# MY1 FINAL MONITORING REPORT

Odell's House Mitigation Project

**RE: WLS Responses to NCDEQ DMS Review Comments for Task 7 Submittal, Draft Monitoring Year 1 Report for the Odell's House Mitigation Project, DMS Full-Delivery Project ID #100041, Contract #7420, Neuse River Basin, Cataloging Unit 03020201, Johnston County, NC**

### Odells House GW-4

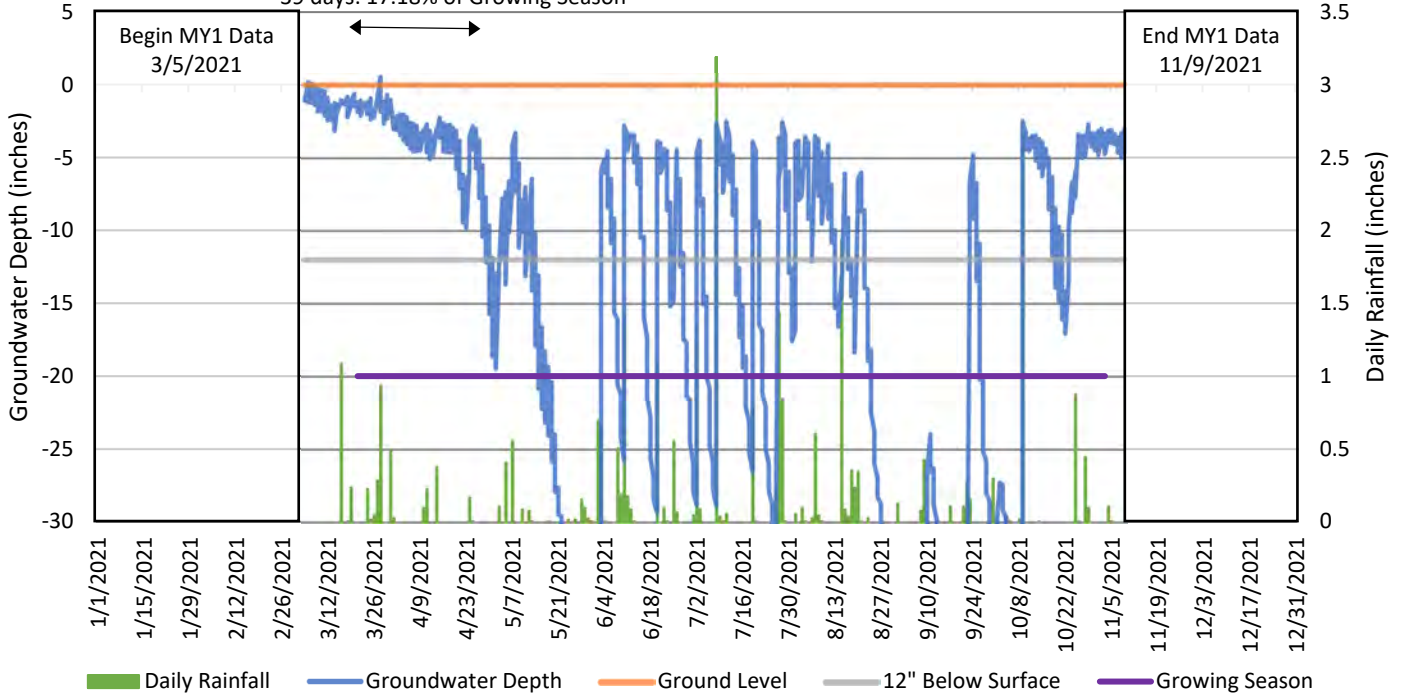
- **Please ensure that only days within the growing season are being included in the groundwater hydrologic criteria calculations. GW-4 shows 57 days but based on the provided data this gauge met criteria for 39 days continuously during the growing season. Please also adjust the line indicating the duration that gauge data met criteria so that the beginning of the line coincides with the beginning of the growing season.** Response: Data for GW-4 was corrected to include only days within the growing season. The graph for GW-4 was updated accordingly. Gauge graphs were revised to correctly reflect the duration that gauges met criteria.
